SUBJECT: Review of Dual-Mode Lunar Roving  
Vehicle (DLRV) Design Definition  
Study - Case 320

DATE: October 29, 1969

MEMORANDUM FOR FILE

FIGURE 1

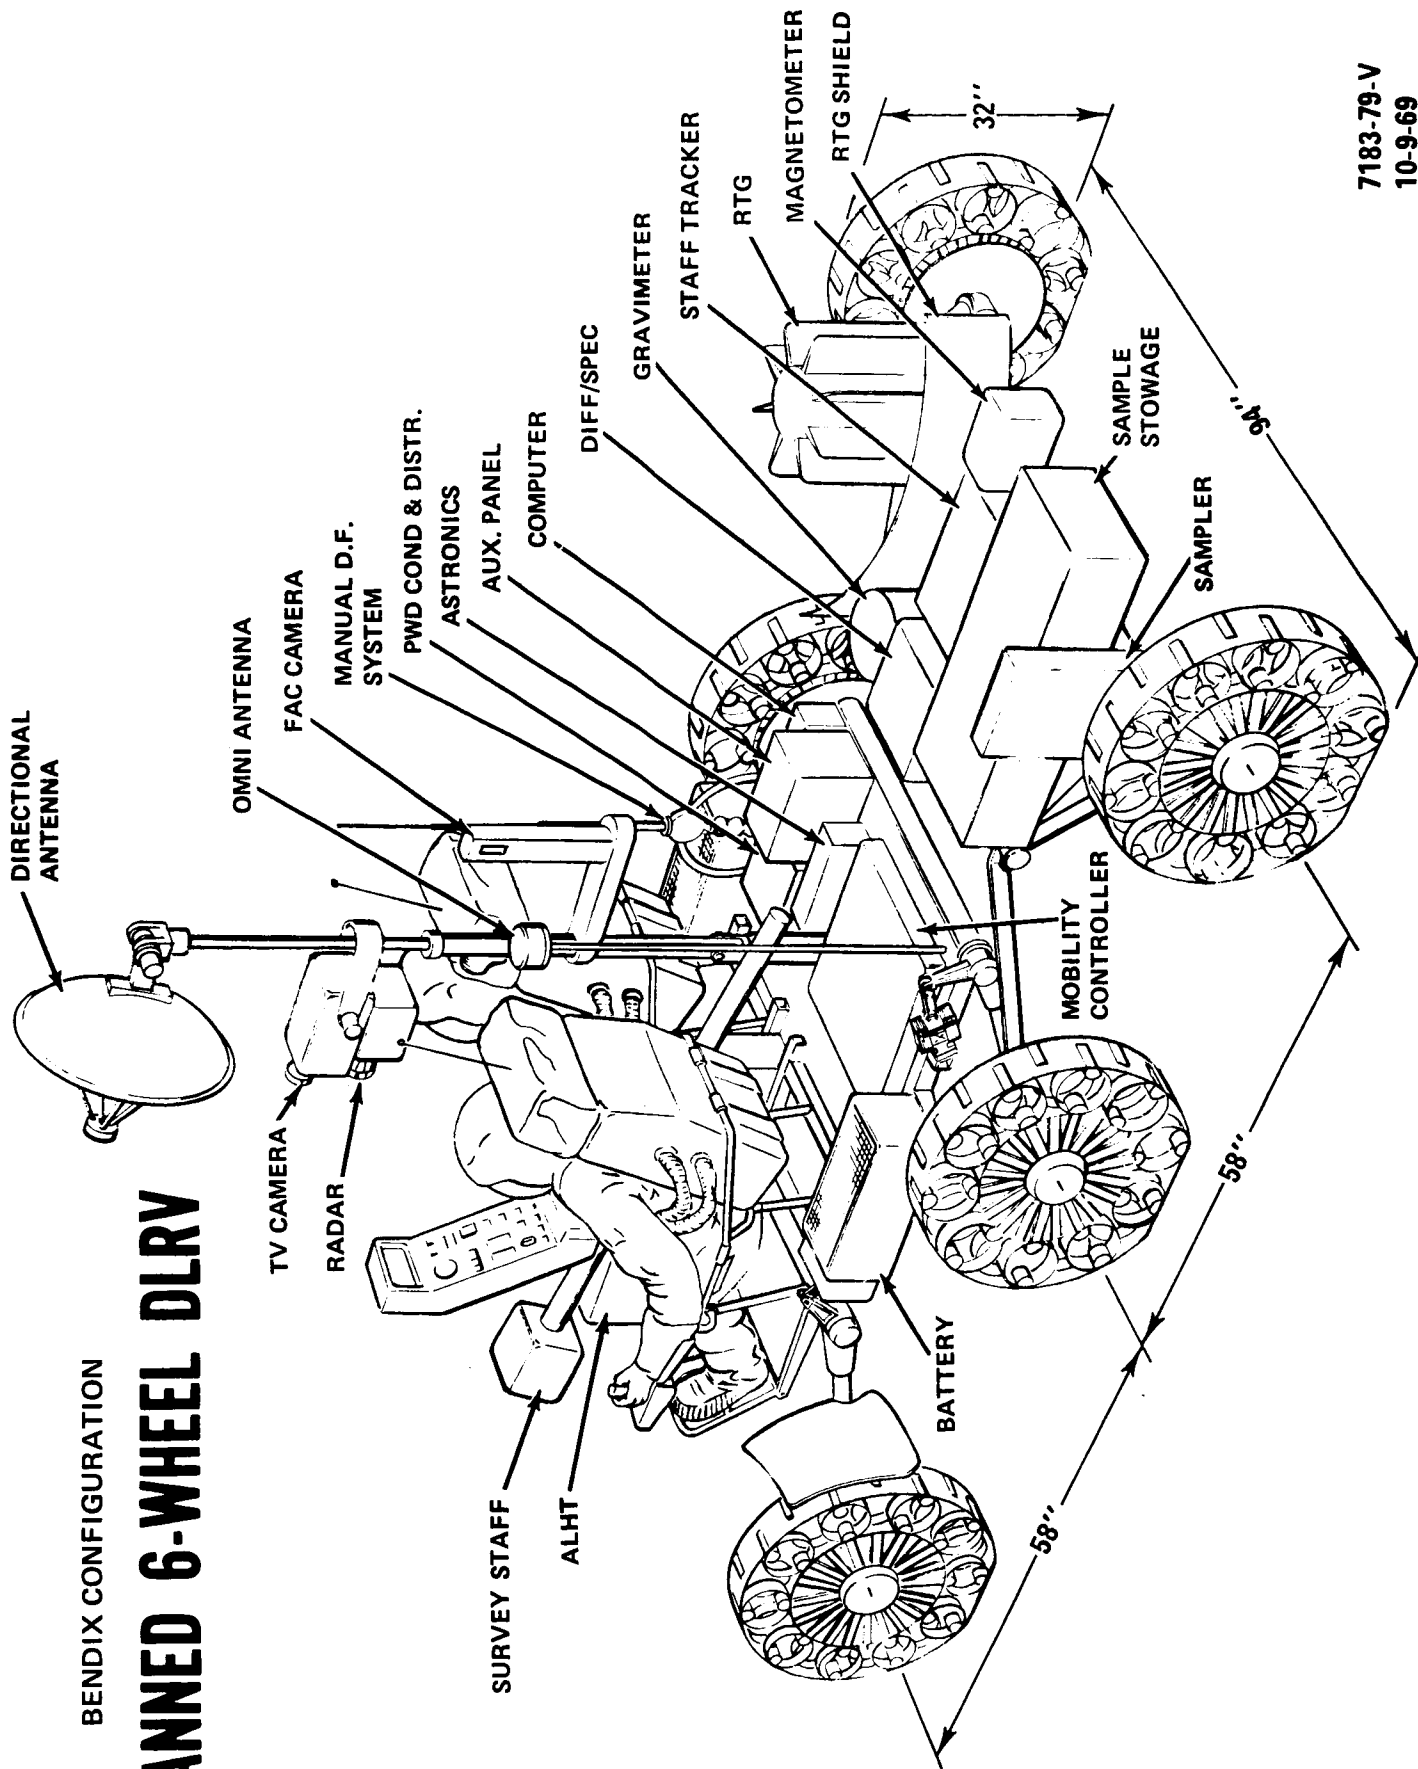
1. General: Figures 1 and 2 show the baseline configurations of the Bendix and Grumman vehicles, respectively. Both contractors have proposed a 6 x 6 (six wheel, six motor) vehicle, capable of stowage in two bays of the LM descent stage. The Bendix design features a four wheel forward chassis and a two wheel trailer, with Ackerman steering of the front and rear wheel pairs. The Grumman concept is a fully articulated vehicle with the front joint locked in pitch for crevasse negotiability. Bendix has optimized its design for six wheeled operation, but has also provided for degraded manned operation in a four wheel mode. Grumman has proposed a double ended configuration (driving in opposite directions manned and unmanned) to optimize arrangement of scientific equipment.

Two significant differences in the general configurations proposed by the contractors are evident. The Bendix design, with a 58", equal separation wheel base and an overall length of 148" is considerably shorter than the 96" wheel base, 230" overall length, Grumman concept. (The effect of this difference on vehicle performance is not yet clear.) In addition, Bendix has chosen to place its crew members side by side at the front of the vehicle. Grumman, assuming primarily single-astronaut operation, has placed only one crew member in the forward driving position, while making provision for a second crewman with a sling located between the front two vehicle sections.

It should also be noted that the Bendix vehicle does not meet the turning radius requirement of one vehicle length. No mention of this shortcoming has been made by either Bendix or MSFC.

FIGURE 2

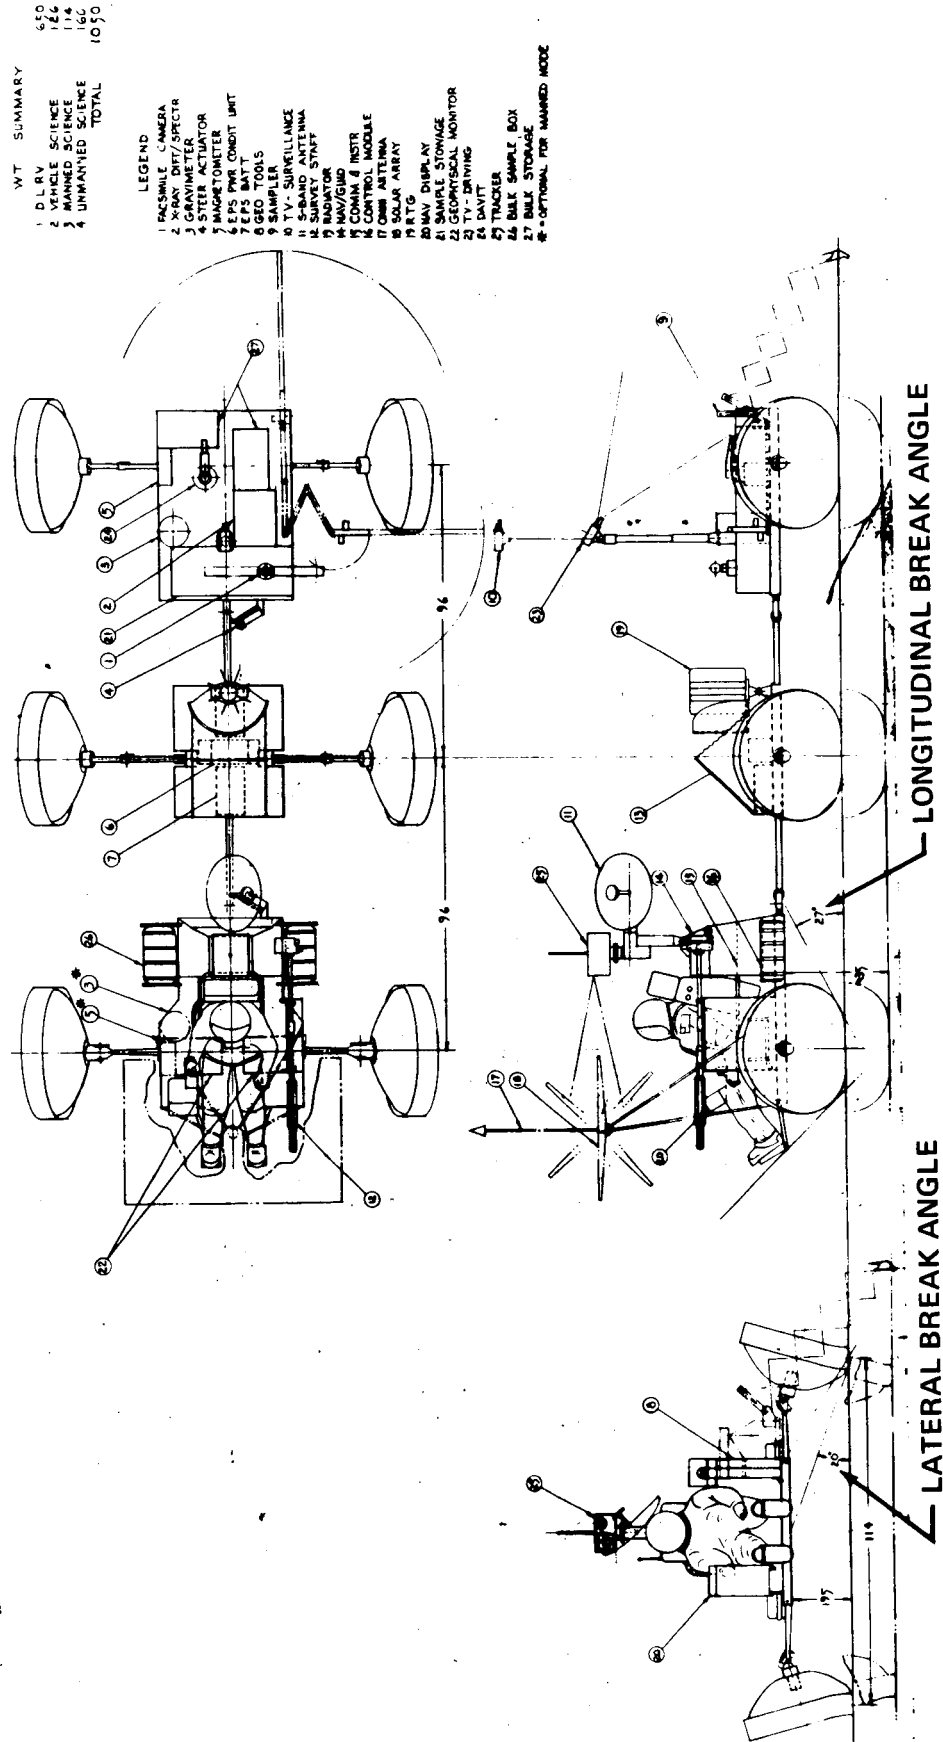
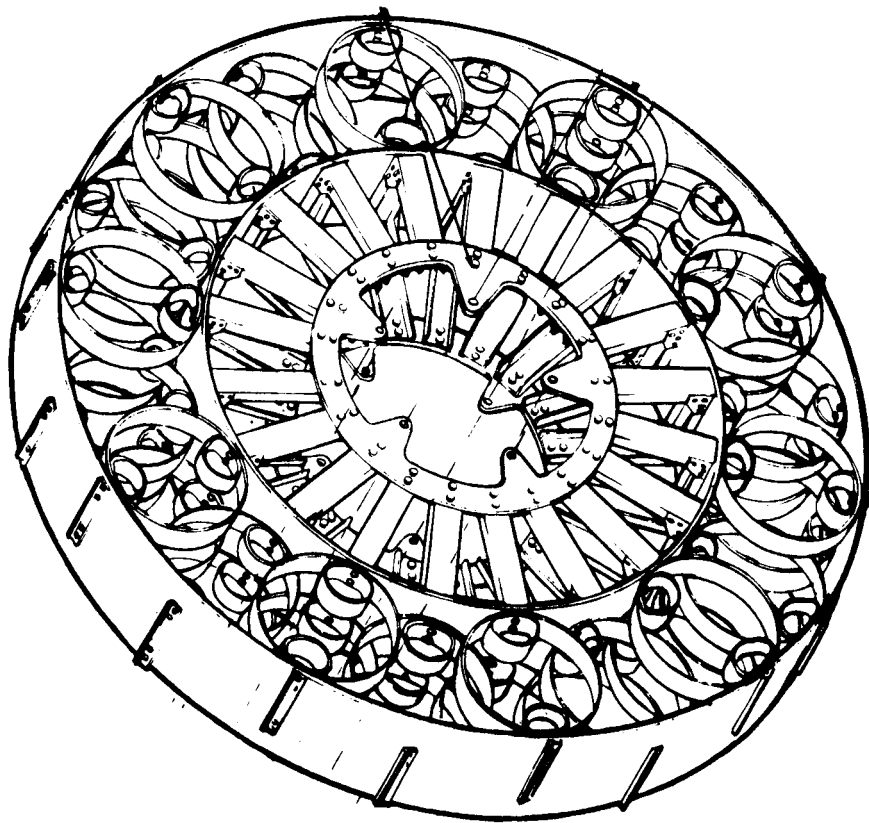
The other major SOW requirement still unresolved is the break angle for unmanned operation. The geometry of this angle is shown in Figure 2. As the science payload and arrangement are yet to be determined, it seems likely that, when decisions are made in those areas, better correlation with the specifications will be provided.

FIGURE 3

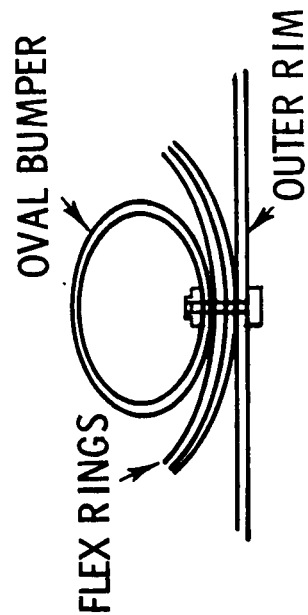
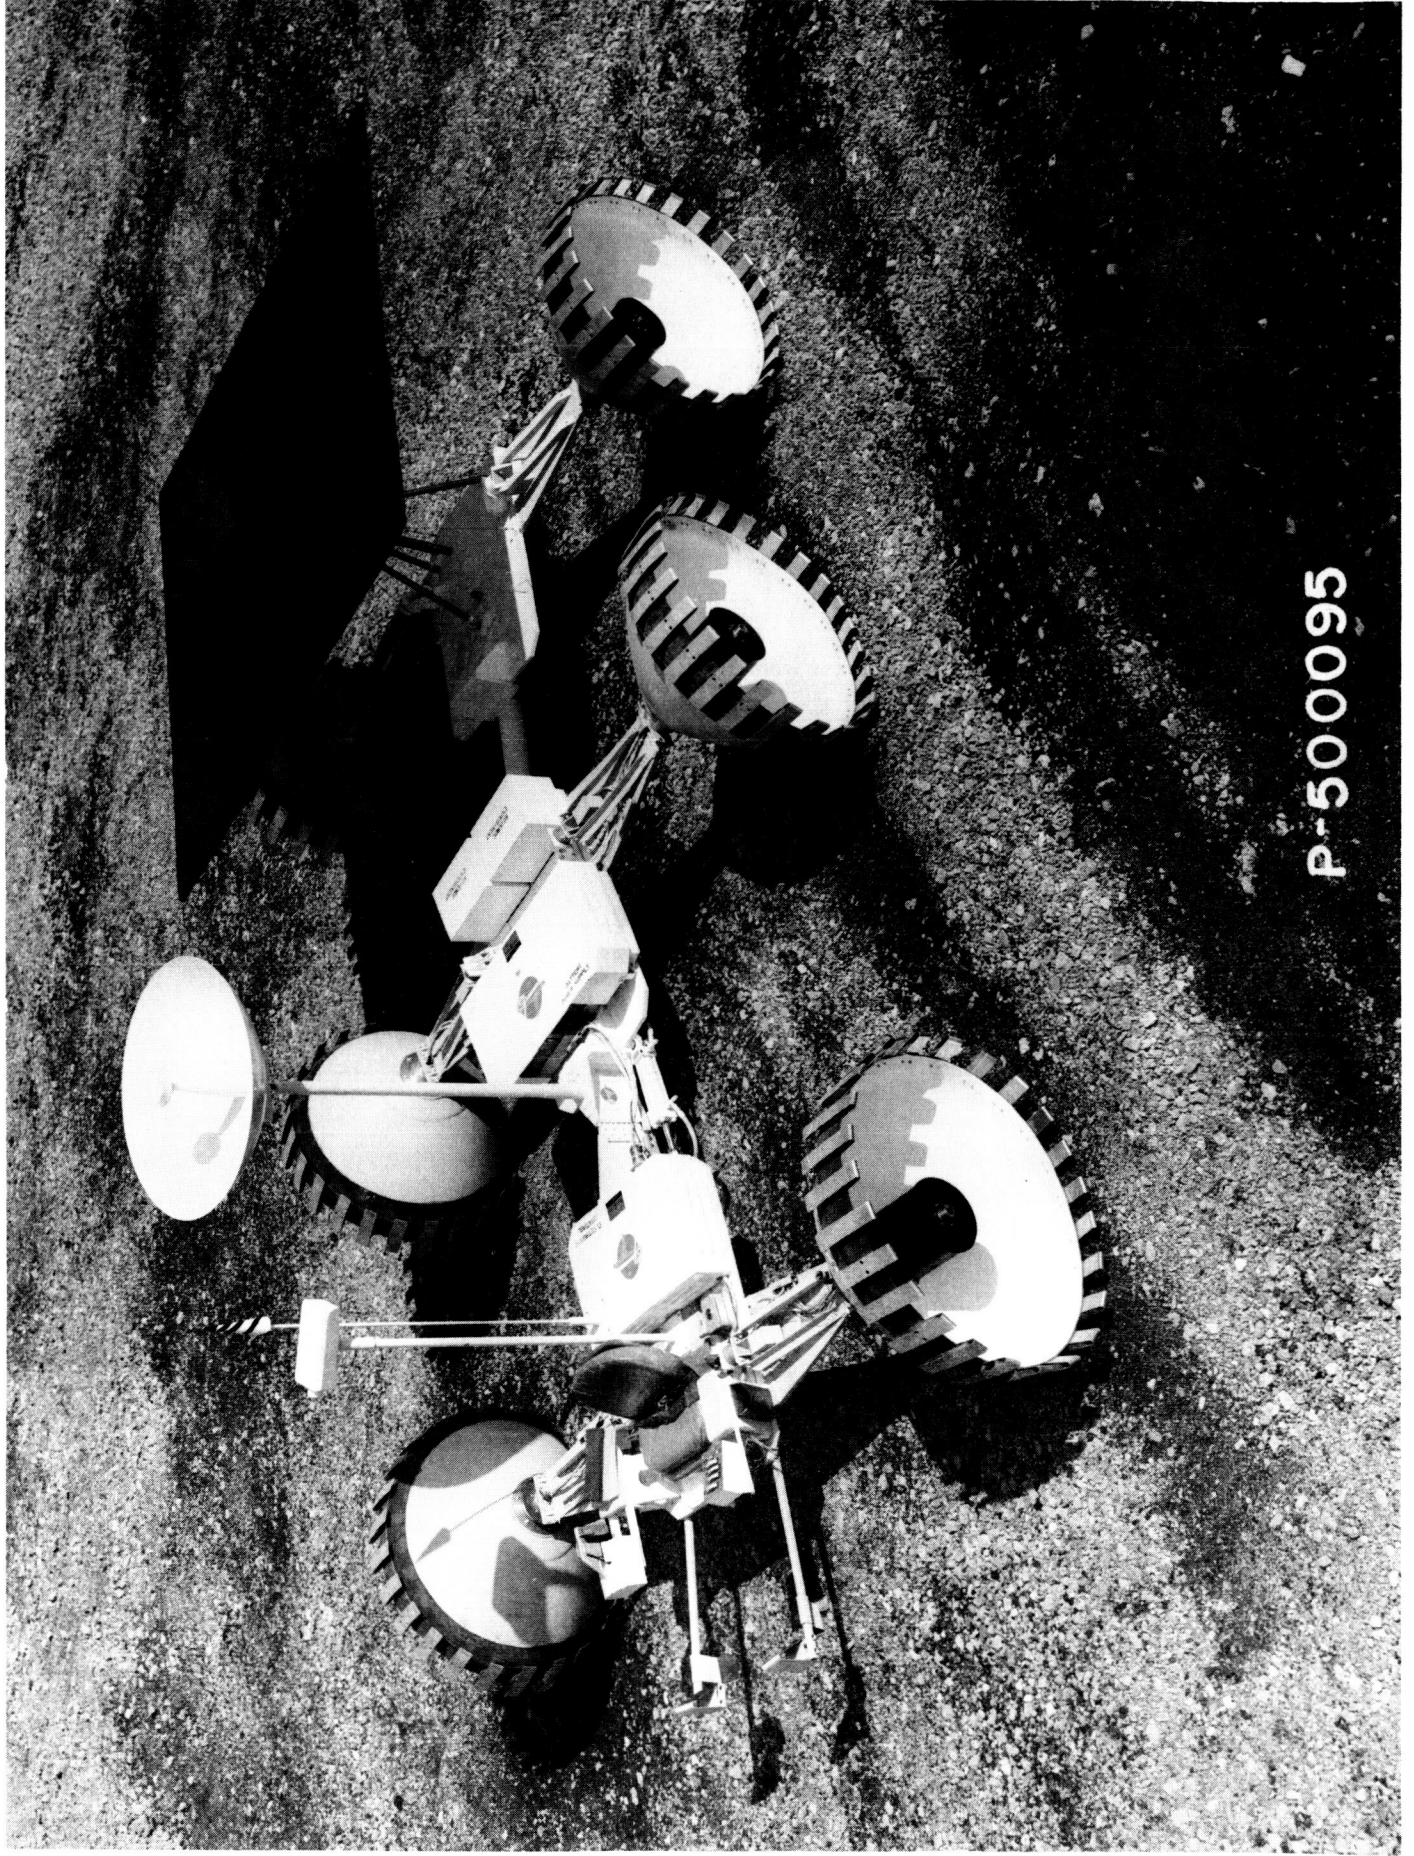
2. Wheels and Suspension: The wheel and suspension systems proposed by the two contractors indicate significant differences in design philosophy. The metal-elastic Bendix wheel, shown in Figure 3, is a formidable exercise in mechanical design. Due to the complex structure, the fatigue reliability for long duration missions remains in question. By comparison, Grumman's continuous structure conical wheel, shown in Figure 4, is an extremely simple design. Recent work of Waterways Experiment Station, however, raises doubt as to the performance capabilities of this wheel in its unmodified version [1]. As presented in the current studies, the Bendix wheel is 32 inches in diameter while the Grumman wheel has a 38 inch diameter. Neither wheel appears to provide the required slope climbing capability of  $35^\circ$  in soft soil. As a result, both contractors were directed to examine the impact of low wheel loading (0.1-0.2 psi) on performance and design of their vehicles.
